PUBLIC HEARING MEMORANDUM

SUBJECT: **Petition #179-21** for SPECIAL PERMIT/SITE PLAN APPROVAL to create a 6-acre development using land from 333 Nahanton Street to construct a 174-unit congregate living facility with amenity space, connected to the Coleman House via an enclosed walkway, on a new 218,583 subdivided portion of the lot, to determine density and dimensional controls, to allow assigned parking, to allow parking in the side setback, to allow parking within five feet of a building containing dwelling units, to allow reduced parking stall width and depth, to allow reduced accessible stalls, to allow reduced aisle width, to waive perimeter landscaping requirements, to waive lighting requirements for outdoor parking and to allow three years to exercise the special permit at **333 Nahanton Street** and **677 Winchester Street**, Ward 8, Newton Centre, on land known as Section 83 Block 35 Lots 04 and 04B, containing approximately 1,225,207 sq. ft. of land in a district zoned SINGLE RESIDENCE 1. Ref: 7.3.3, 7.4, 7.3.2.E, 3.4.1, 3.3.3.A.3, 3.1.2.A.3, 5.1.3.E, 5.1.8.A.1, 5.1.8.A.2, 5.1.8.B.1, 5.1.8.B.2, 5.1.8.B.4, 5.1.8.C.1, 5.1.9.A.1.i, 5.1.10.A.1 of the City of Newton Rev Zoni

Proposed Site Plan

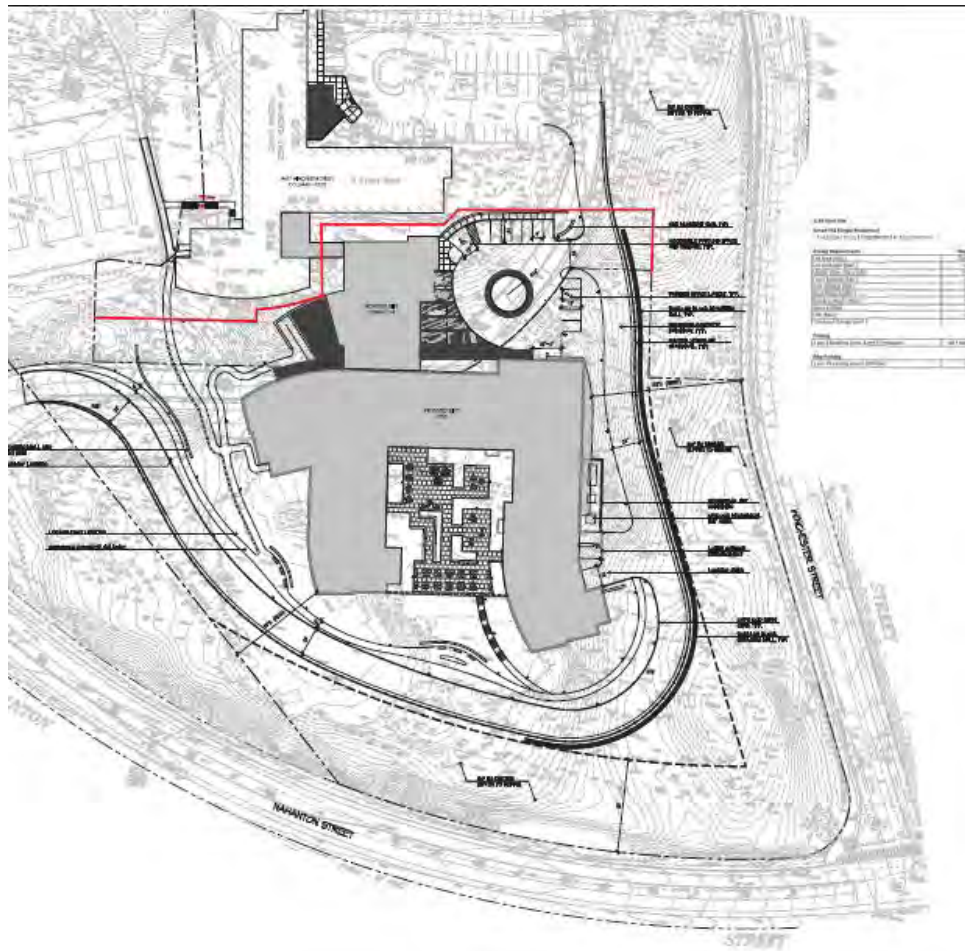
As detailed in the attached memorandum (**Attachment C**), the petitioner presented to the Urban Design Commission (UDC) on May 12th and the UDC commented that it is a “wonderful” project that will be a big asset to Newton. The UDC generally found the building to be handsome but found the stone base to be taller than human scale, resulting in a heavy feel to the building. They also recommended the petitioner consider further varying the heights and breaking down the massing further. The UDC was also concerned about the length of the corridors and lack of natural light in the corridors, and they recommended the petitioner consider adding a second elevator lobby to minimize the walking distance for elderly residents. The Planning Department requests that the petitioner provide updated building elevations which are at a larger scale and include material call outs and dimensions.

The proposed site plan reroutes the internal roadway to allow for the construction of the proposed building, connecting to the existing Coleman House. The roadway will loop around the southern end of the building and will connect to a circular driveway in front of the main entrance at the connector building. The roadway will then connect to the existing roadway, which provides access to the JCC campus. The reconfigured roadway will require significant retaining walls due to the steep grades onsite. The Associate City Engineer has requested additional information, including roadway cross sections. The UDC has also requested a full site section from the JCC or Coleman House down across the street to the farm to fully understand the slope difference.

found the landscape approach to be great, but they thought the connector building entrance was stark and could be softened with landscaping. The UDC also recommended creating a vision for the outdoor front entrance that includes space for residents and visitors to gather and not just keeping it as a drop-off area.

Suggested opportunity to divert flow to a rain garden or underground infiltration for treatment.

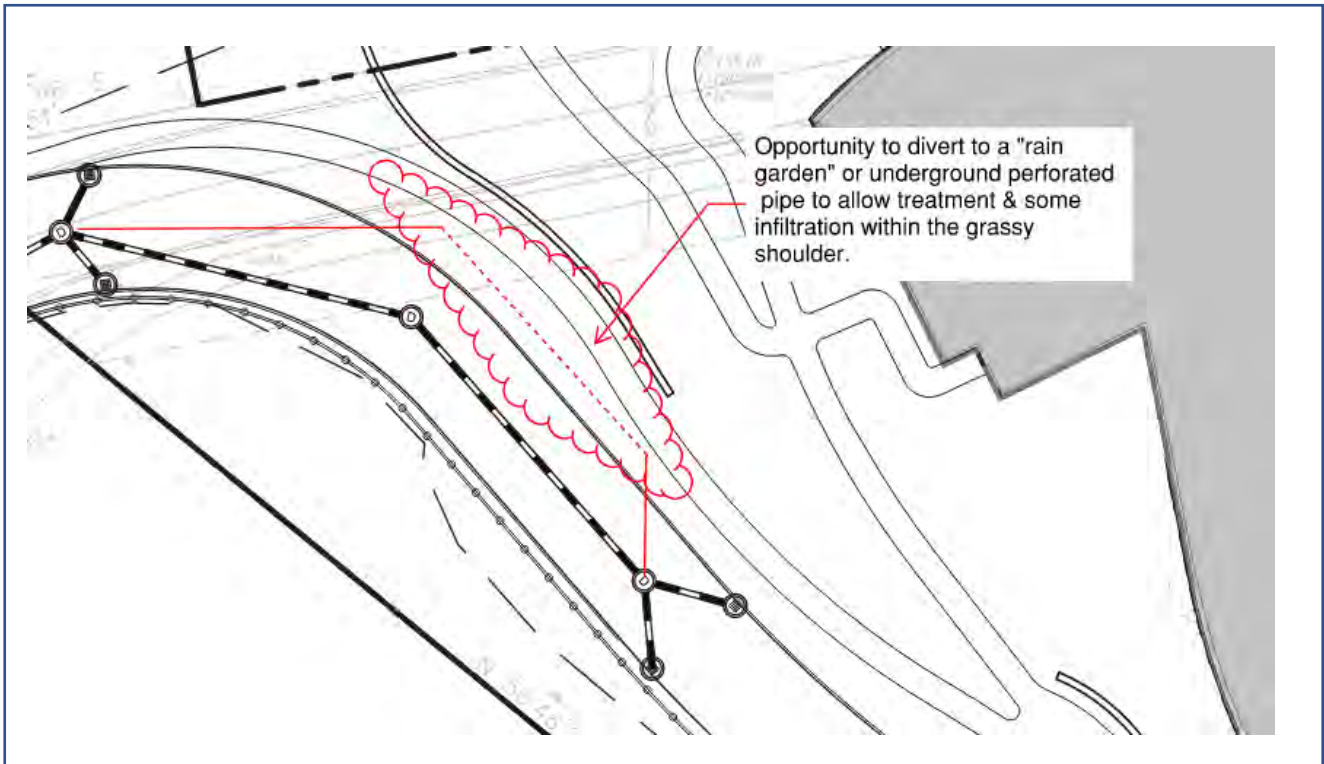
The design incorporates a stormwater collection system that includes infiltration and treatment for the new roof areas and portions of the new access road, designed in accordance with the DEP and DPW Stormwater Regulation & Policies. However, portions of the road, approximately 300 feet near Nahanton Street stormwater is only collected via catch basins and directly connect to the City's drainage system. I believe there is an opportunity to divert the pipe system to the grassy shoulders along the road to either rain gardens or perforated pipe to allow some infiltration/treatment rather than direct discharge.

City Assessor Map

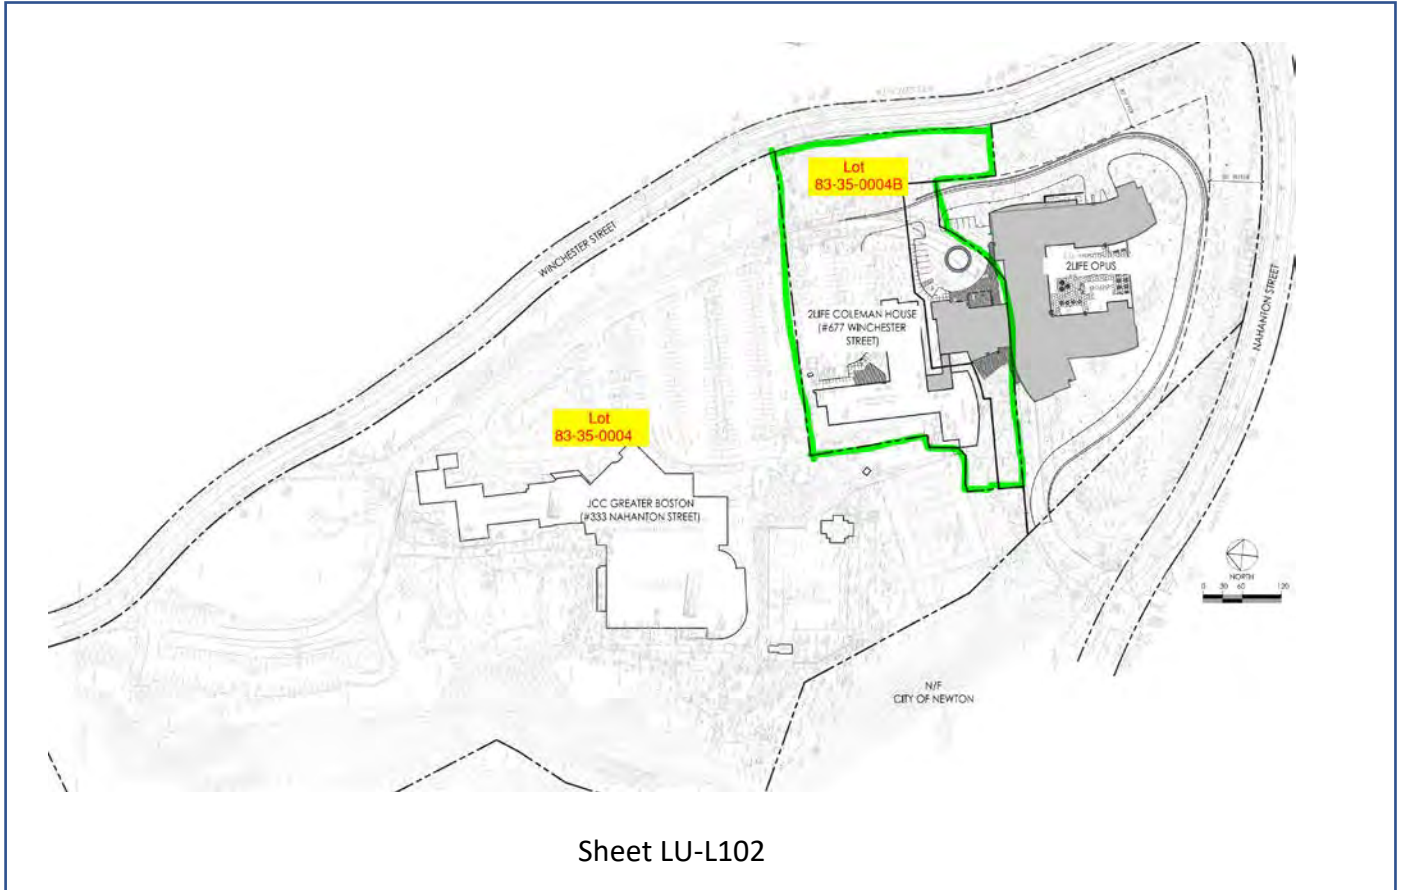
According to the City's Assessors maps (see below) there are two lots, if the special permit is approved an Approval Not Required [ANR] plan will be required in accordance with Massachusetts General Laws Chapter 41 Section 81P requiring the division and/or combination of lots to be delineated for proper filing at the Registry of Deeds.
